July 24, 2001
RC-01-0135

Subject: VIRGIL C. SUMMER NUCLEAR STATION
DOCKET NO. 50/395
TECHNICAL SPECIFICATION AMENDMENT REQUEST TSP 99-0090
SPENT FUEL POOL STORAGE EXPANSION

This proposed change will increase the spent fuel pool storage capacity by replacing all eleven existing rack modules with twelve new high density storage racks. These new storage racks will be manufactured and installed by Holtec International.

FIGURE 3.7-1 REQUIRED FUEL ASSEMBLY BURNUP AS A FUNCTION OF INITIAL ENRICHMENT TO PERMIT STORAGE IN REGION 2

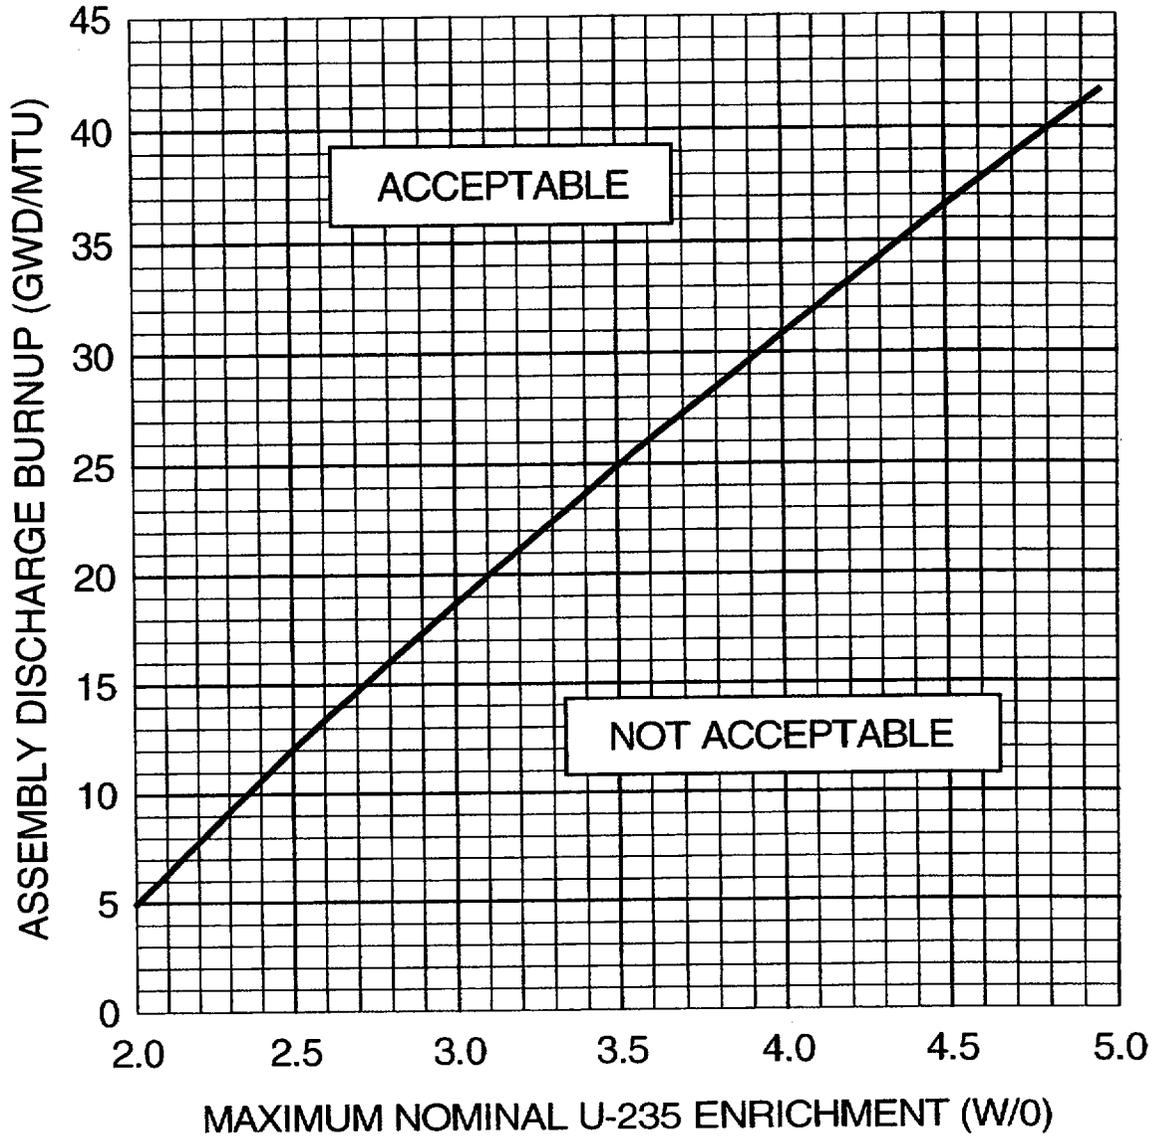
<u>Page</u>	<u>Affected Section</u>	<u>Bar #</u>	<u>Description of Change</u>	<u>Reason for Change</u>
3/4 7-43	3/4.7.12	1	New figure to define acceptable burn-up vs. initial enrichment requirement for Region 2	Criticality analysis for re-rack revised burn-up figure in section 9.
3/4 7-44	3/4.7.13	1	Add new Specification for boron concentration limit during non-refueling fuel evolutions.	Criticality analysis for re-rack determined need for minimum dissolved boron in the event a fuel handling accident should occur.
3/4 9-3	3/4.9.3	1	Reduce the minimum incore hold time before fuel can begin offloading. Establish correlation to Component Cooling Water temperature	Station desire to assist in shorter outages.
3/4 9-3a	3/4.9.3	1	Adding new figure of incore hold time vs. Component Cooling Water temperature	Provide consistent requirements for refueling operations.
3/4 9-11	3/4.9.10	1	Delete specification	Moving specification to Section 3/4.7.

NEW FIGURE

~~3.9.12~~⁷ The combination of initial enrichment and cumulative burnup for spent fuel assemblies stored in Region ~~2 and 3~~ shall be within the acceptable domain of Figure ~~3.9-1 for Region 2 and Figure 3.9-2 for Region 3.~~

FIGURE 3.9-1 REQUIRED IN-CORE HOLD TIME AS A FUNCTION OF COMPONENT COOLING WATER (CCW) TEMPERATURE

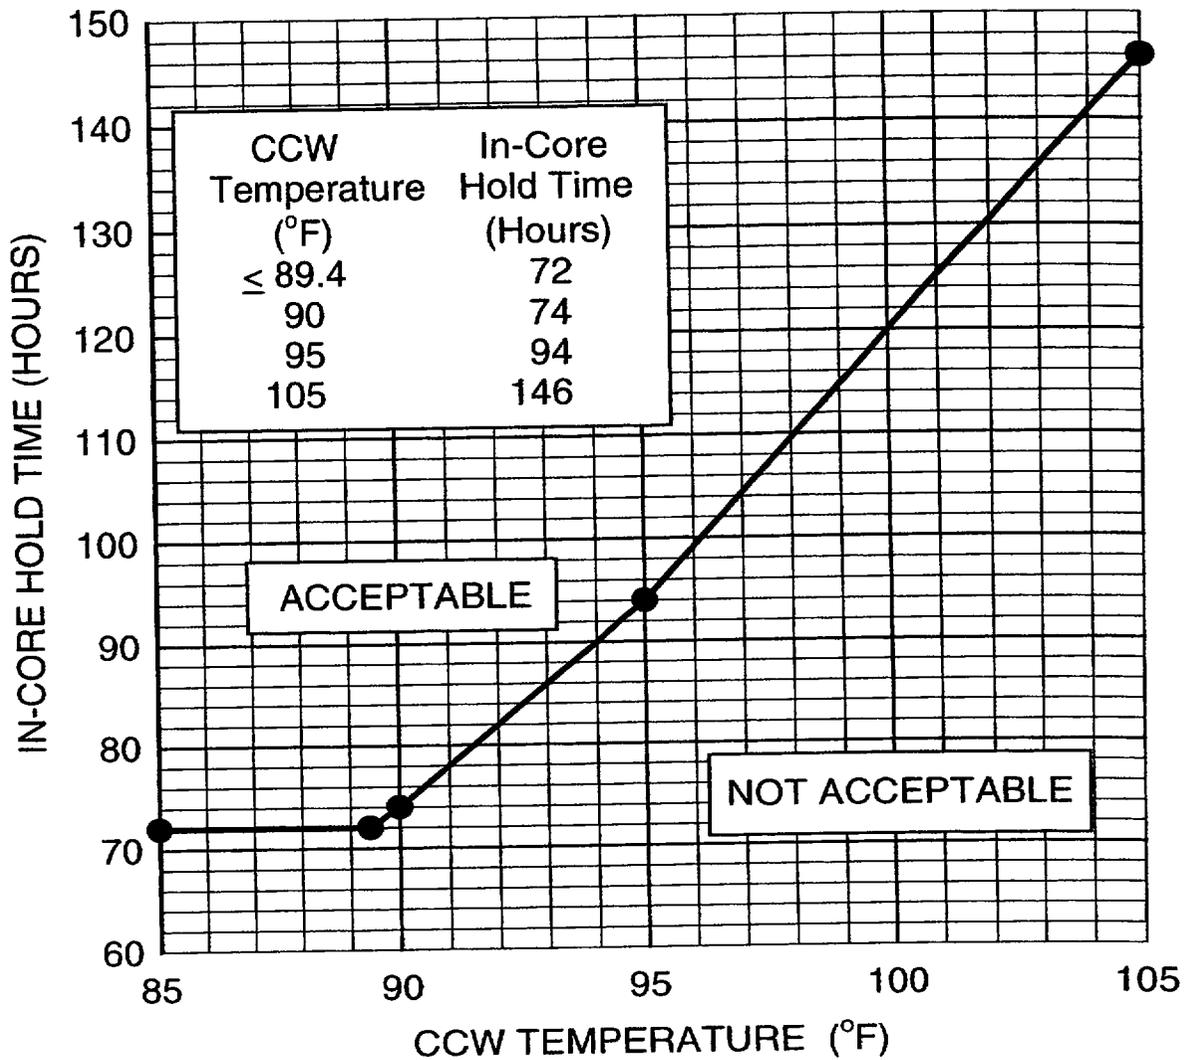
With the reactor subcritical for less than ⁷² ~~100~~ hours, ^{immediately} suspend all operations involving movement of irradiated fuel in the reactor pressure vessel. With the reactor subcritical for greater than 72 Hours but ~~less than~~ not within the acceptable domain of Figure 3.9-1, immediately suspend movement of irradiated fuel in the reactor pressure vessel.

NEW FIGURE

4.9.3.1 The reactor shall be determined to have been subcritical for a period of time within the acceptable domain of Figure 3.9-1 by verification of the date and time of subcriticality prior to movement of irradiated fuel in the reactor pressure vessel.

4.9.3.2 Prior to moving irradiated fuel from the reactor pressure vessel, and at least once every 12 hours during movement of irradiated fuel, verify the CCW temperature at the inlet ^{to} of the Spent Fuel Pool Cooling System heat exchanger is within the acceptable domain of Figure 3.9-1.

FIGURE 3.9-1 MINIMUM REQUIRED FUEL ASSEMBLY BURNUP AS A FUNCTION OF INITIAL ENRICHMENT TO PERMIT STORAGE IN REGION 2

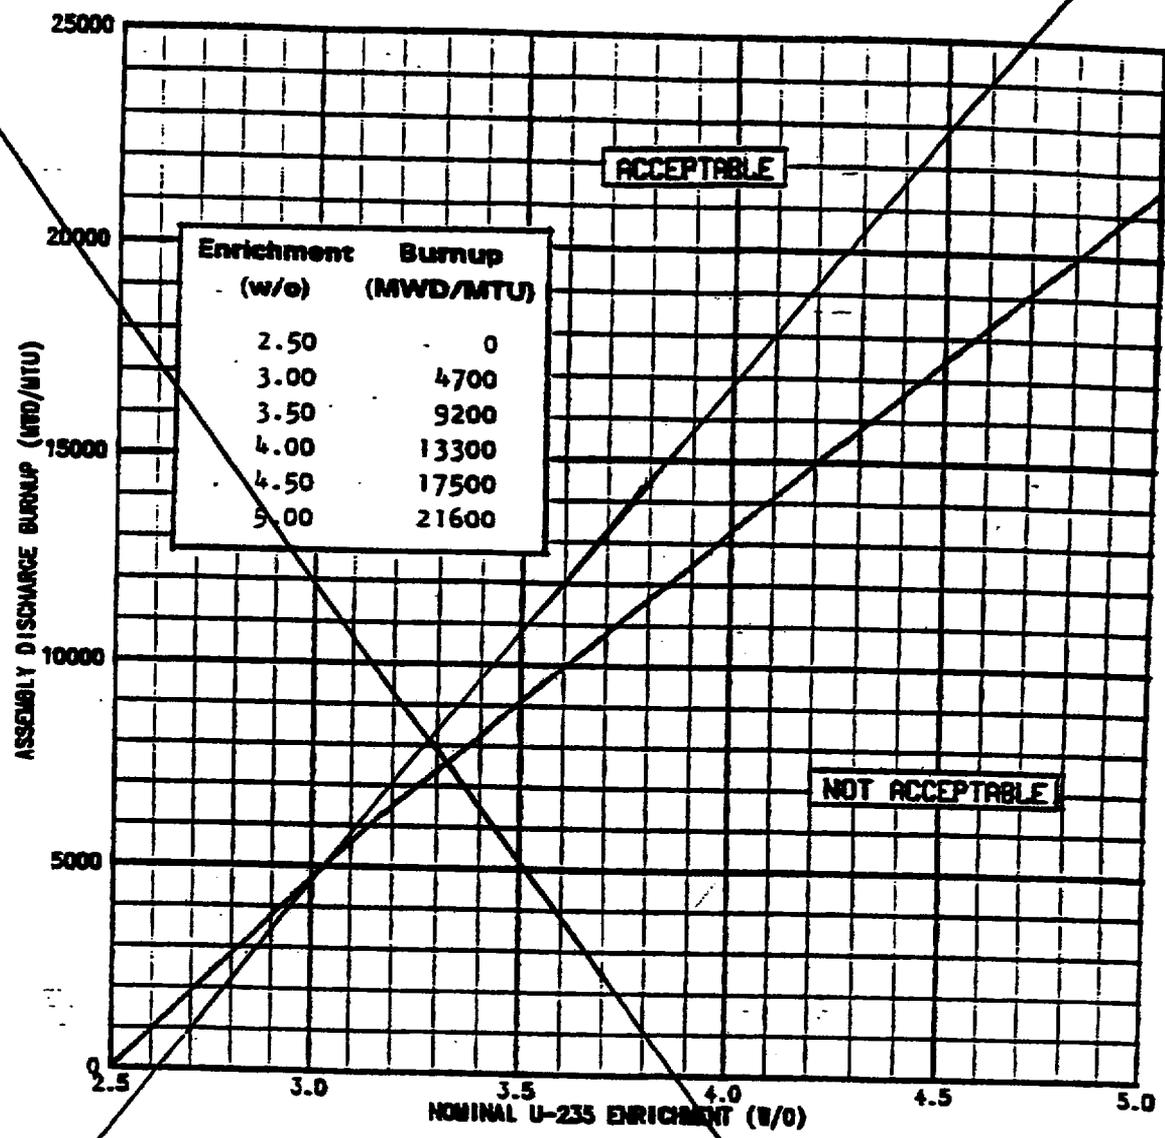
DELETE 3/4.9.12.
REVISED AND MOVED TO 3/4.7.12

DELETE THIS FIGURE

FIGURE 3.9-2 MINIMUM REQUIRED FUEL ASSEMBLY BURNUP AS A FUNCTION OF INITIAL ENRICHMENT TO PERMIT STORAGE IN REGION 3

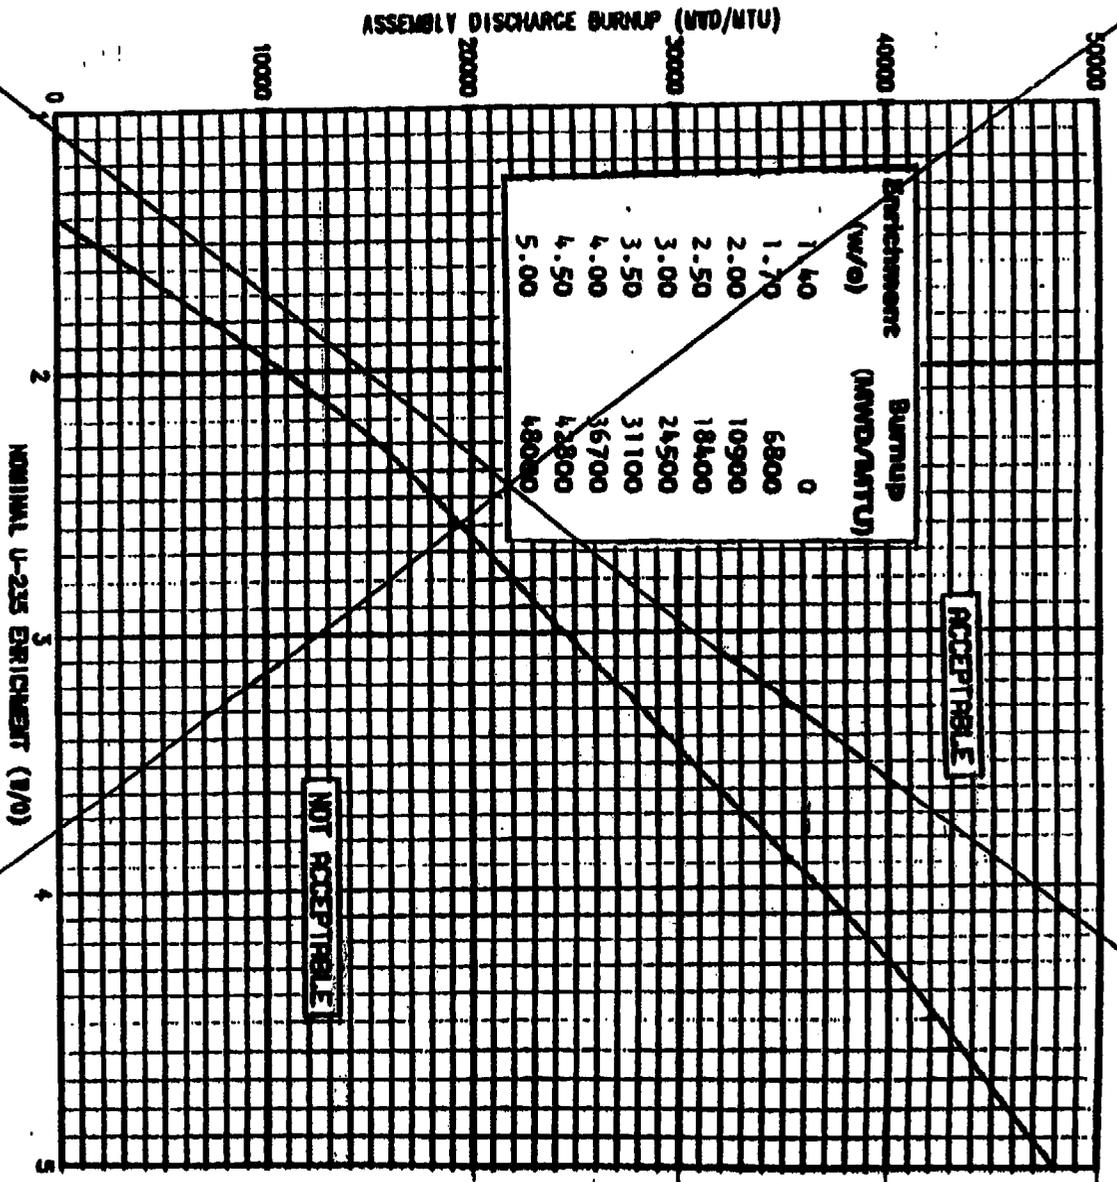
DELETE THIS FIGURE

SOUTH CAROLINA ELECTRIC & GAS CO.
VIRGIL C. SUMMER NUCLEAR STATION
Region 1 Minimum
IFBA Requirements
FIGURE 5.6-1

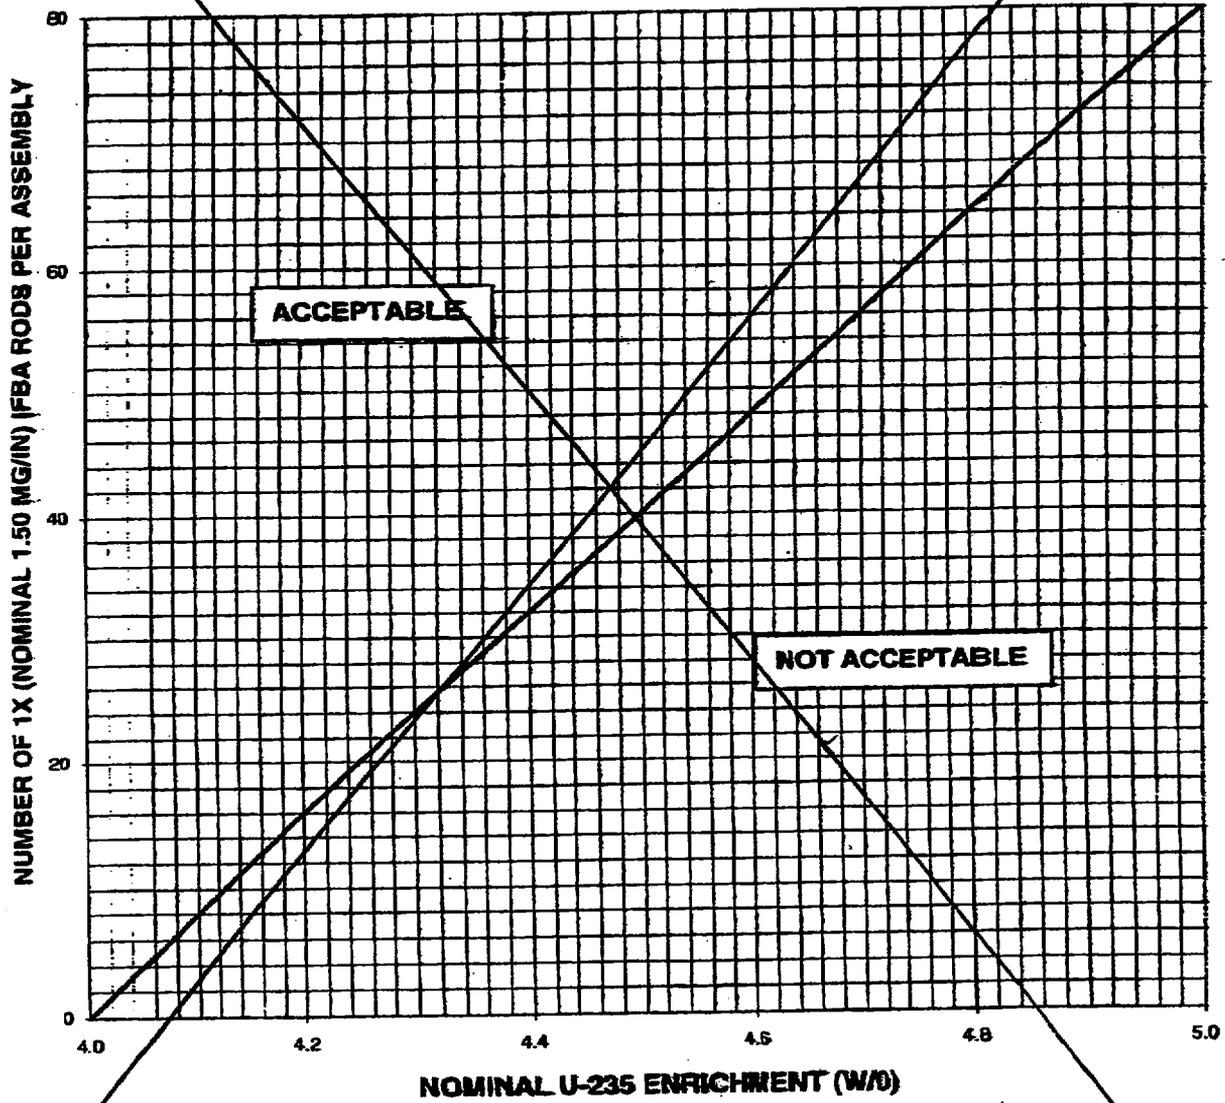
5.6.3	2	Changed storage capacities, 1276 to 1712 cells and moved information to Page 5-7. Left page blank due to Page 5-10.	Revised to reflect re-racked storage capacities.
5-8	Figure 5.6.1	1	Delete Figure 5.6-1; left page blank due to continued page 5-10.	Does not apply to Re-Racked pool Region 1.
5-9			Deleted page; moved information to Page 5-7	Pagination

DELETE FIGURE 5.6-1

5.6.1.1 The spent fuel storage racks consist of 1712 individual storage cells. The cells are grouped into two regions, which are determined based on storage cell spacing as defined below. The spent fuel storage racks are designed, and shall be maintained, with a K_{eff} less than or equal to 0.95 when flooded with unborated water, which includes conservative allowances for uncertainties and biases. This is ensured by maintaining the following for each region:

- a. Region 1- designated for storage of fresh fuel assemblies and fuel assemblies with a cumulative burnup less than the required cumulative burnup for storage in Region 2.
 1. A nominal 10.867 inch center-to-center distance between fuel assemblies placed in the storage rack.
 2. A maximum nominal initial enrichment of 4.95 weight percent U-235.
- b. Region 2 – designated for storage of discharged fuel assemblies.
 1. A nominal 9.07 inch center-to-center distance between fuel assemblies placed in the storage rack.
 2. A cumulative burnup within the acceptable domain defined by Figure 3.7-1.
